LOCATION  
*93 St. Marks Place*

## APPLICATION TO ALTER, REPAIR, ETC.

Location 93 St Marks Place

Amendment to Application No. 1829

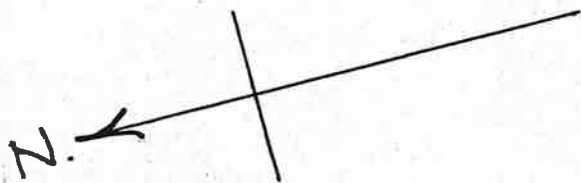
- #1. Detail of proposed roof enclosure filed herewith.
- #2. Iron beams specified for new floors are new and framing plan filed. These iron beams to be built into brick walls above and free of present roof and boarded with 2" planks laid 1/16" apart.
- #3. Enclosure of frame porch for toilet and bath room is old work, and has been so since house was erected. Bath room on 2nd floor is also old work, the only new work here is the toilet room on 1st floor built in corner of present extension and new mullion made in window to take partition.
- #4. 1/4" steel never slip plates to be used on iron roof beams instead of wood flooring.
